PETITION NO. 98-58
 FOR PUBLIC HEARING

PORTER PROPERTY TECHNICAL DATA SHEET

SUBJECT: Administrative approval for Petition No. 98-58 Grubb and Bissell Patrick, Wachovia Bank, N.A. tax parcels 183-131-04 and 06.

SUBJECT: Administrative Approval for Petition No. 98-58 Grubb and Ellis Bissell Patrick, Wachovia Bank, N.A. Tax parcels 183-131-04 and 06.

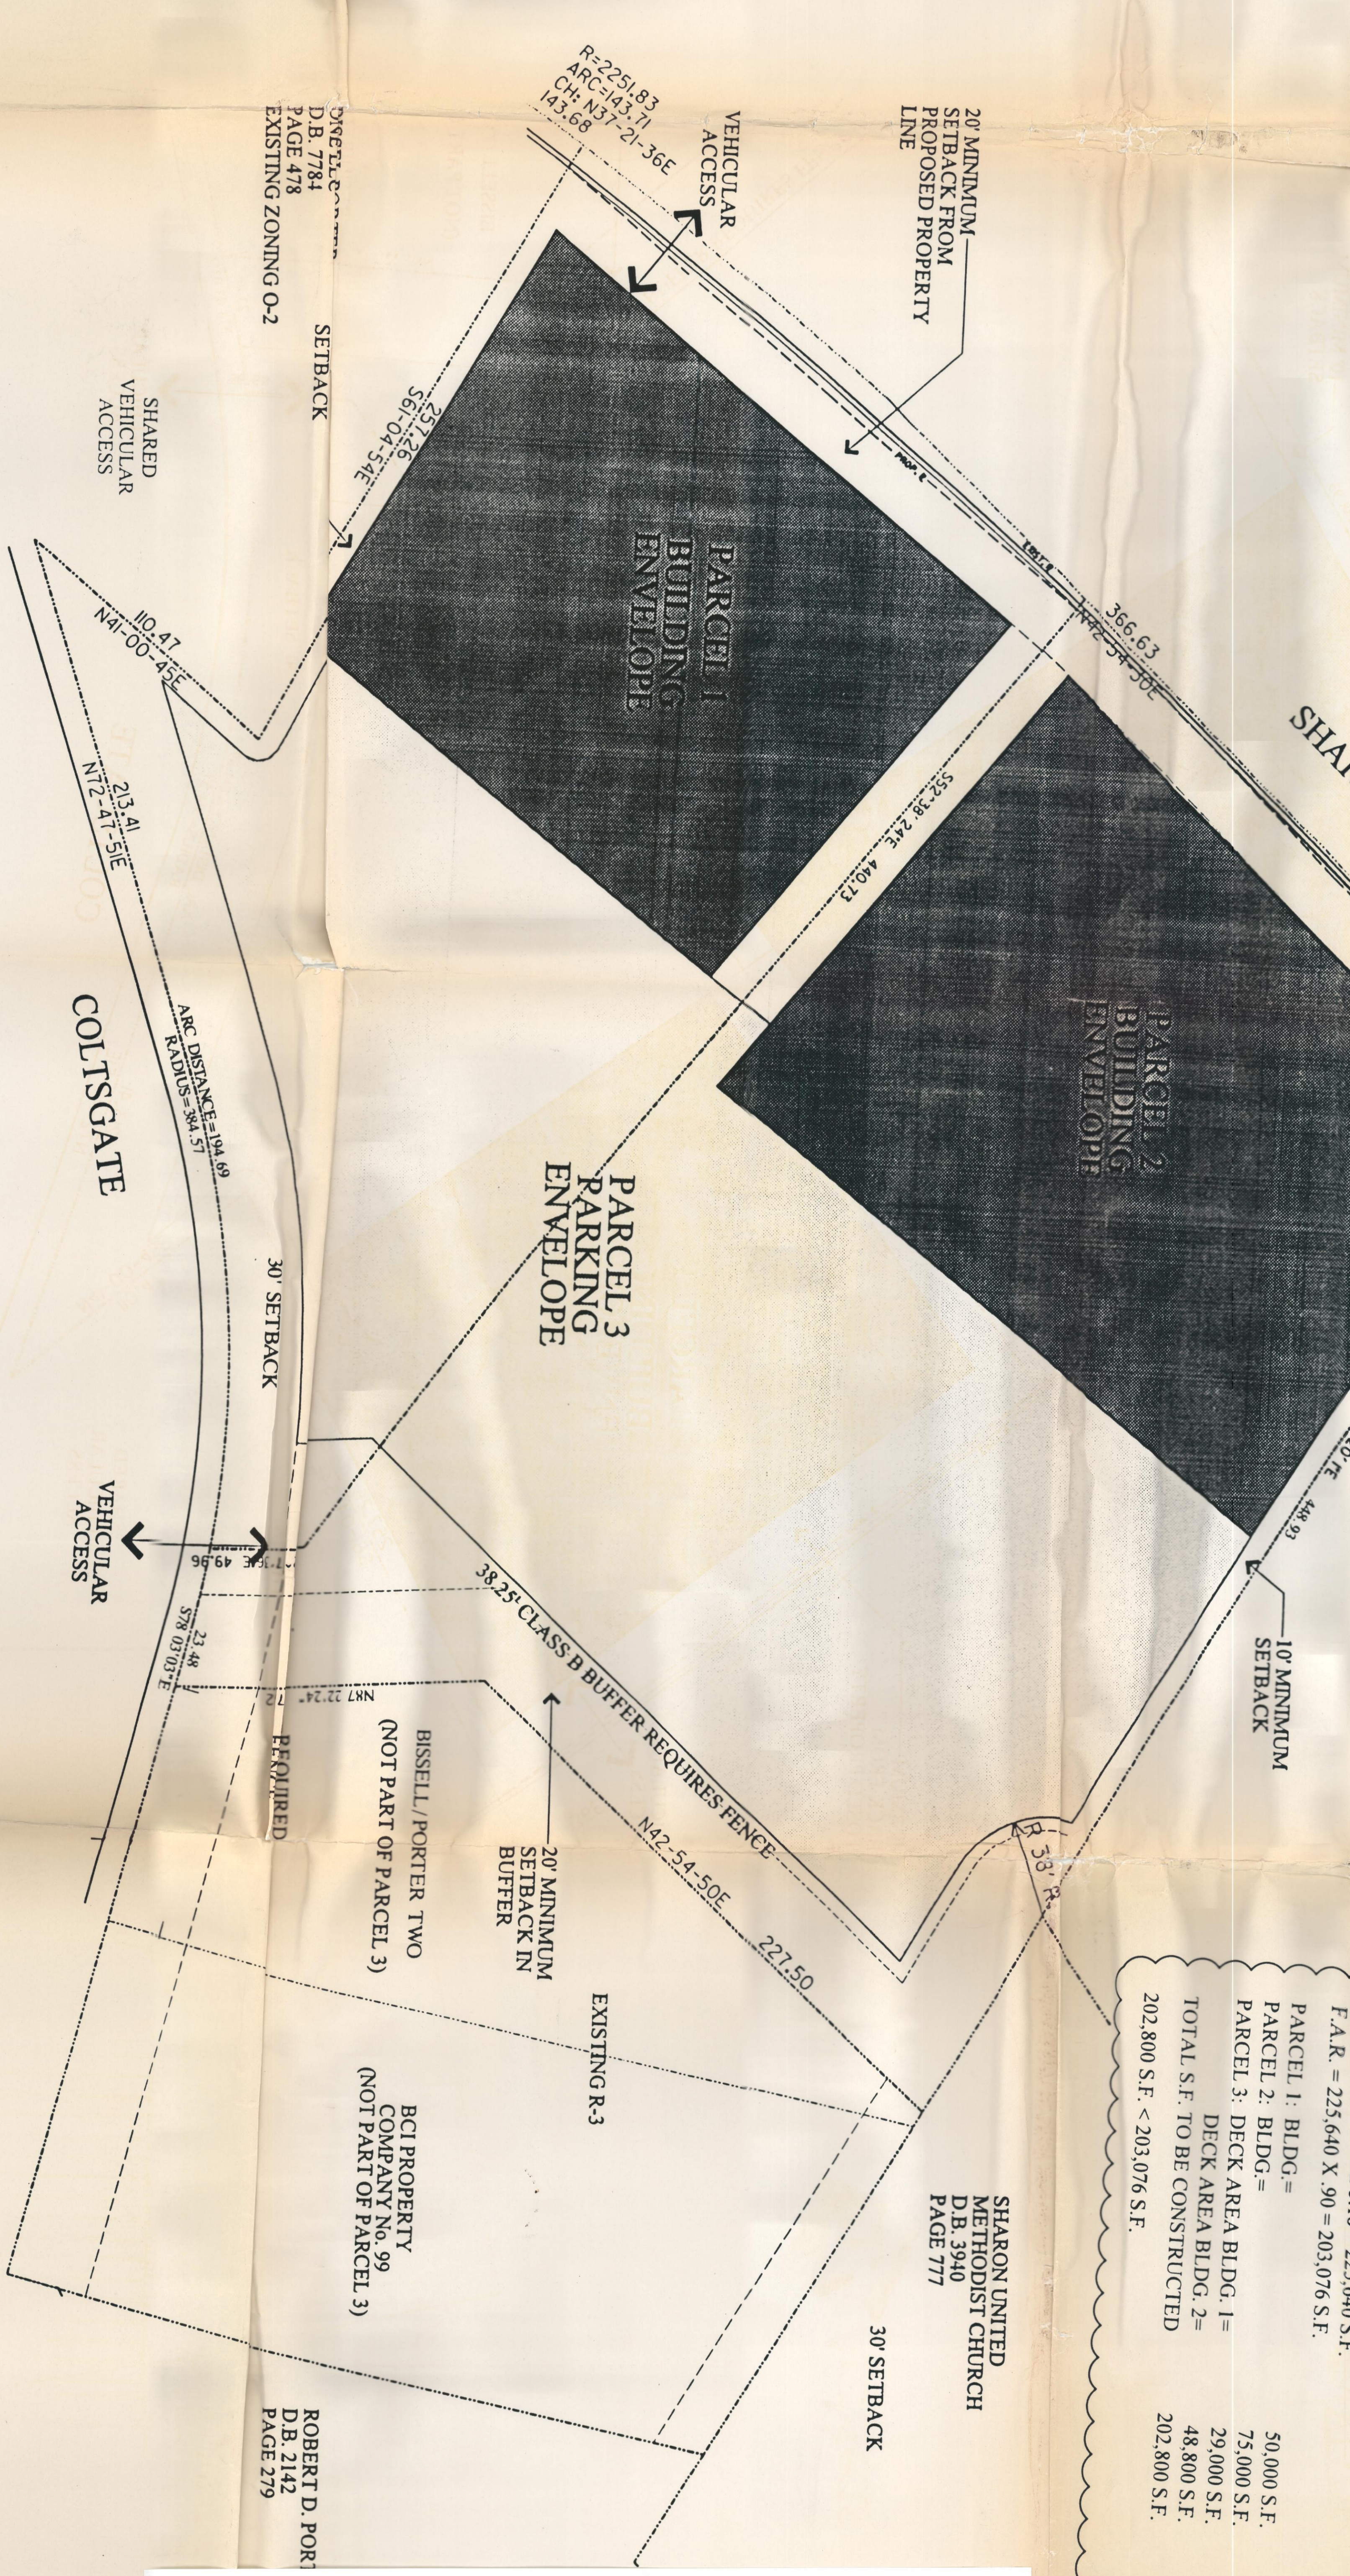
Attached is a copy of the revised plan for the above mentioned rezoning petition. The plan has been revised to correct an ambiguity in the square footage as shown in the development standards and site data. The correct square footage is 50,000 square feet for parcel 1, 75,000 square feet for parcel 2 and 77,800 square feet for the parking deck for a total of 202,800 square feet on the site. These corrected figures do not exceed the allowable FAR in the O-1 district and clarify the originally approved plan therefore, I am administratively approving this revised plan. Please use this revised plan when evaluating request for building permits and certificates of occupancy.

F.A.R. = 225,640 X .90 = 203,076 S.F.	
PARCEL 1: BLDG. =	50,000 S.F.
PARCEL 2: BLDG. =	75,000 S.F.
PARCEL 3: DECK AREA BLDG. 1 =	29,000 S.F.
DECK AREA BLDG. 2 =	48,800 S.F.
TOTAL S.F. TO BE CONSTRUCTED	202,800 S.F.
202,800 S.F. < 203,076 S.F.

LANDSCAPE PLAN

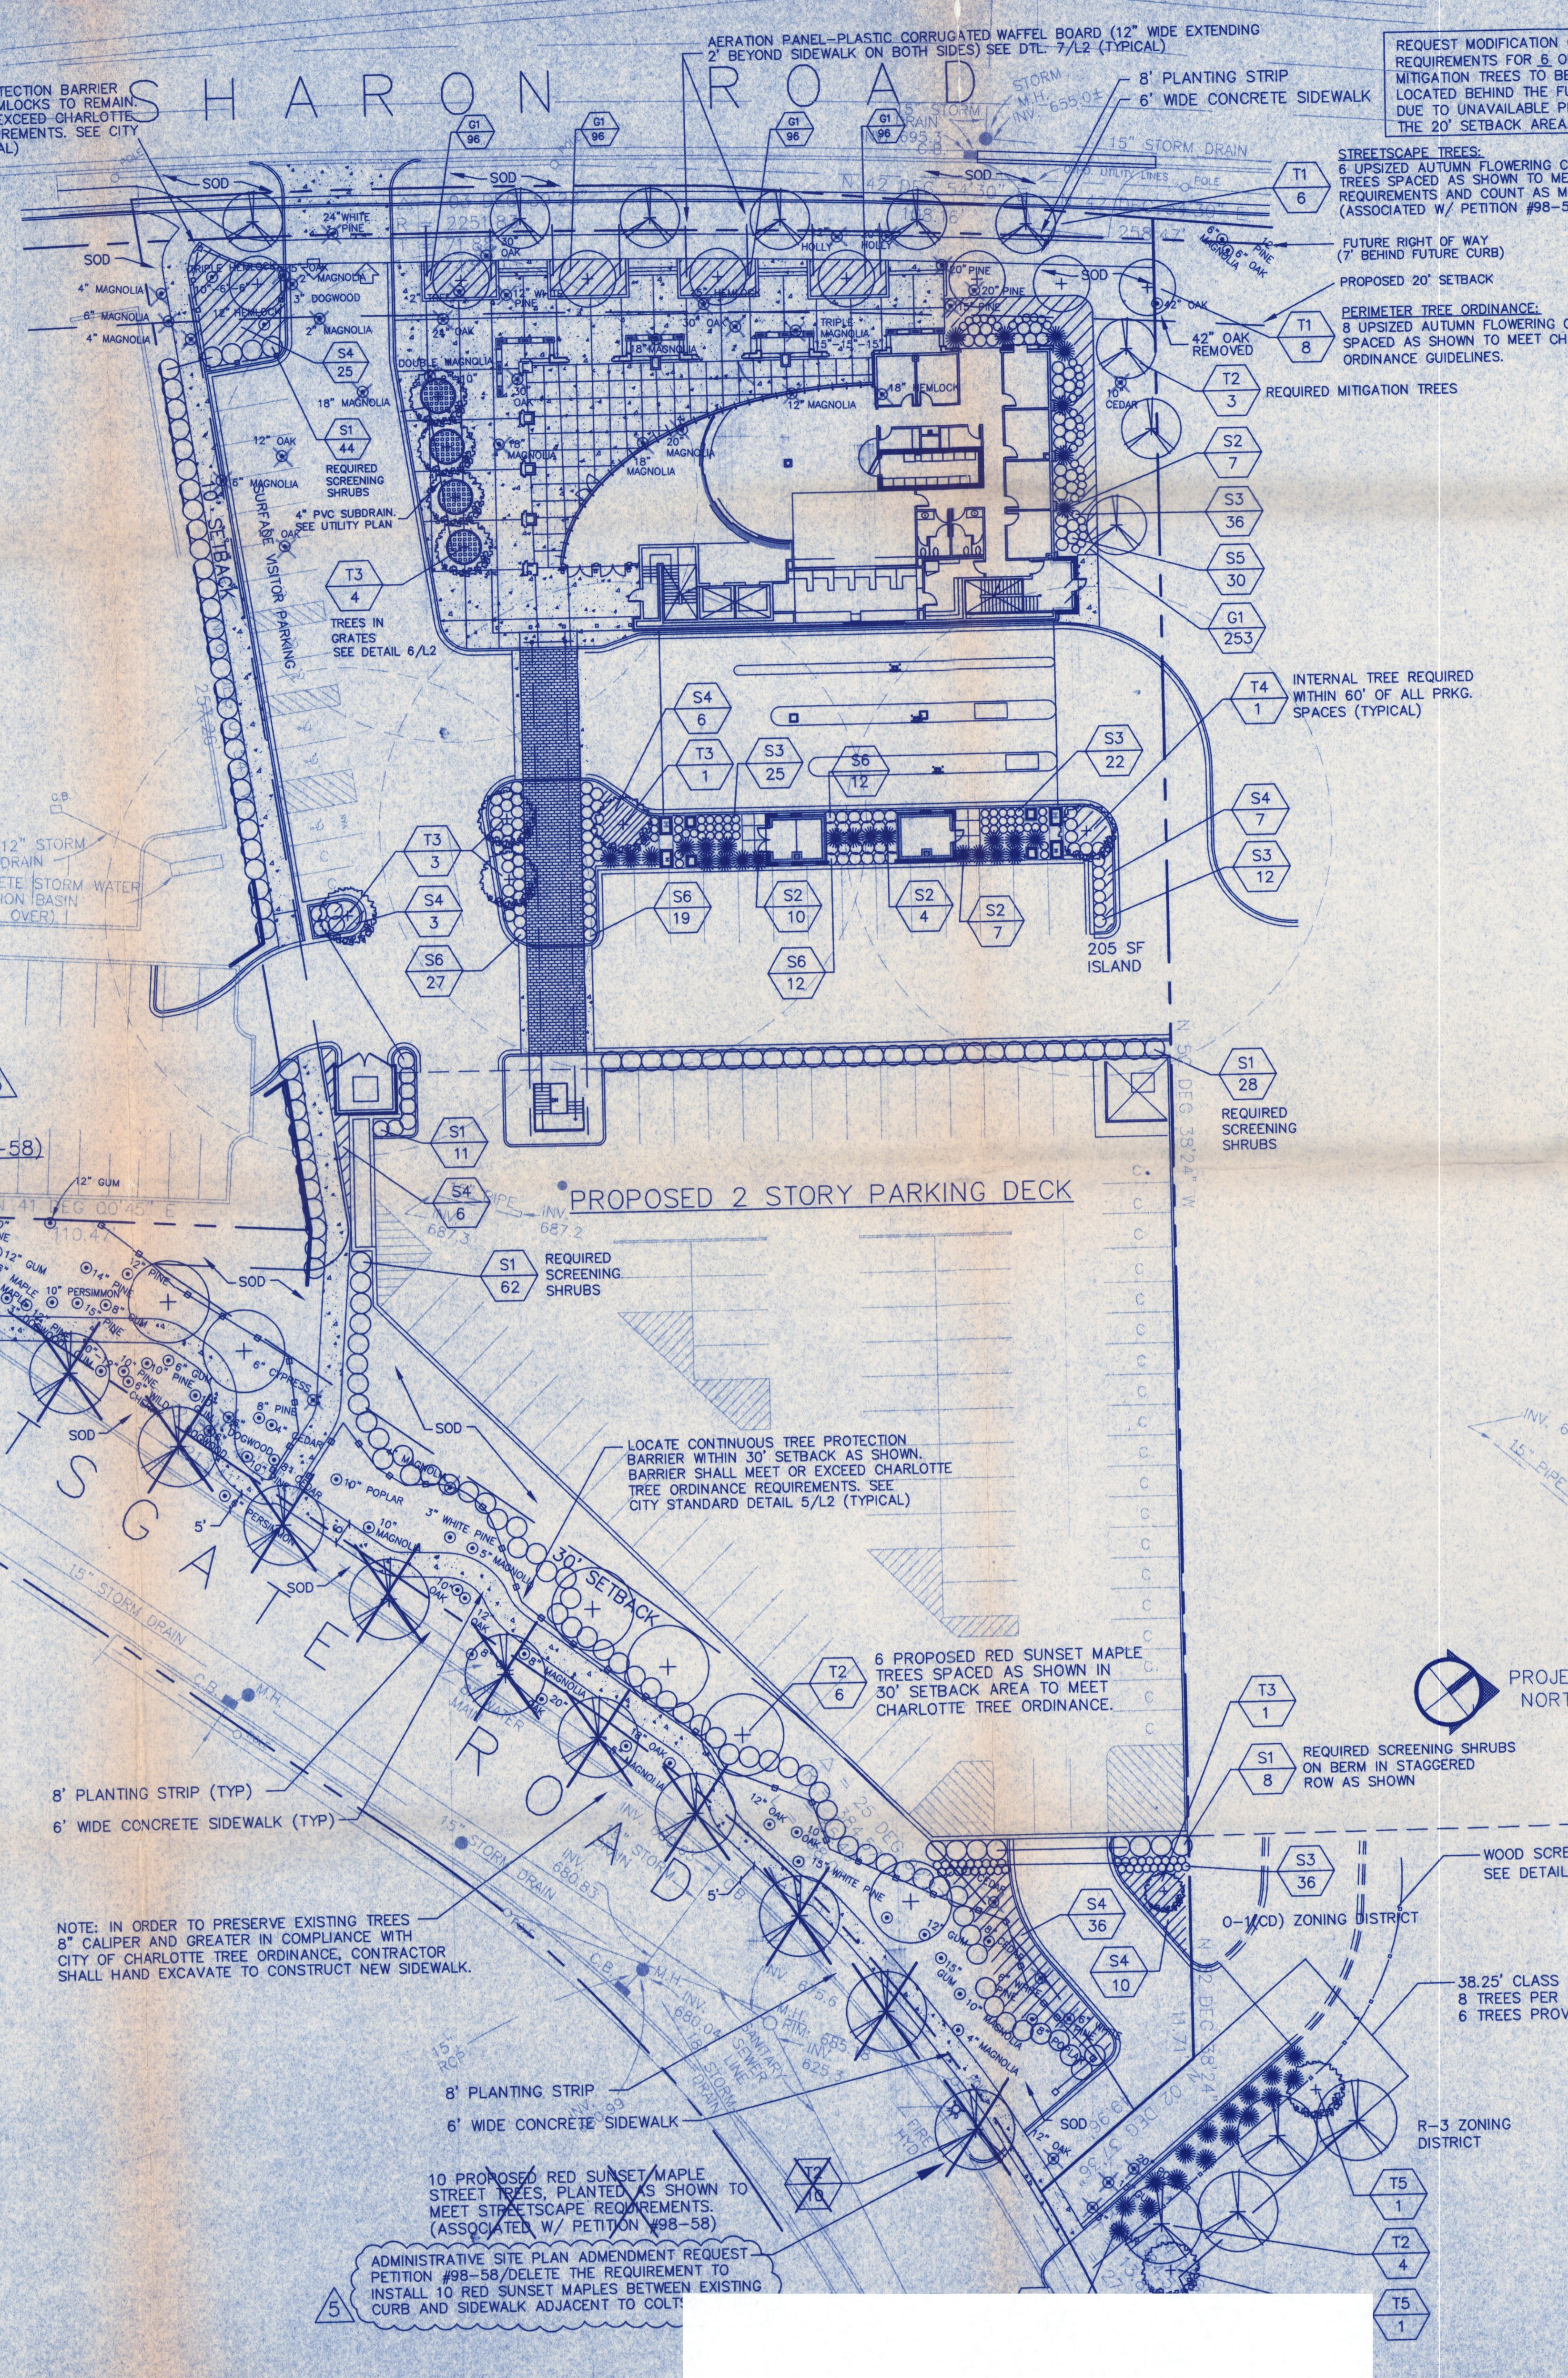
REQUEST MODIFICATION OF TREE MITIGATION REQUIREMENTS FOR 6 OF THE 9 REQUIRED MITIGATION TREES TO BE STREETScape TREES LOCATED BEHIND THE FUTURE BACK OF CURB DUE TO UNAVAILABLE PLANTING SPACE IN THE 20' SETBACK AREA.

20 JULY 1998
REV 8/25/98 CITY ENG
9/24/98 PER ZONING EXPRESS REVIEW
REVISED 10/13/98 PER URBAN FORESTRY AND OWNER FOR RELEASE OF BUILDING PERMIT
REVISED 10/20/98 PER ARCH. REVISIONS TO ELEC./MECH. DRIVE-THRU
REVISED 12/22/98 PER CLIENT AND URBAN FORESTRY
REVISED 9/21/99 ADMINISTRATIVE SITE PLAN AMENDMENT REQUEST TO PETITION #98-58 TO DELETE 10 PERIMETER RED MAPLES ADJACENT TO CURB ON COLTSGATE ROAD

Attached is a copy of the revised plan for the above rezoning petition. The plan has been revised to reflect changes in the landscaping requirements along Coltsgate Road. This revised plan does not reflect any other changes to the presently approved site plan. Since these landscaping changes are minor, I am administratively approving this revised plan. Please use this revised plan when evaluating request for building permits and certificates of occupancy.

11. COLTSGATE = 381.48'
OF "PERIMETER" TREES = 0 LARGE MATURING PER SITE PLAN AMENDMENT REQUEST PETITION #98-58

STREETScape TREES:
6 UPSIZED AUTUMN FLOWERING CHERRY STREET TREES SPACED AS SHOWN TO MEET STREETScape REQUIREMENTS AND COUNT AS MITIGATION TREES. (ASSOCIATED W/ PETITION #98-58).
FUTURE RIGHT OF WAY (7' BEHIND FUTURE CURB)
PROPOSED 20' SETBACK
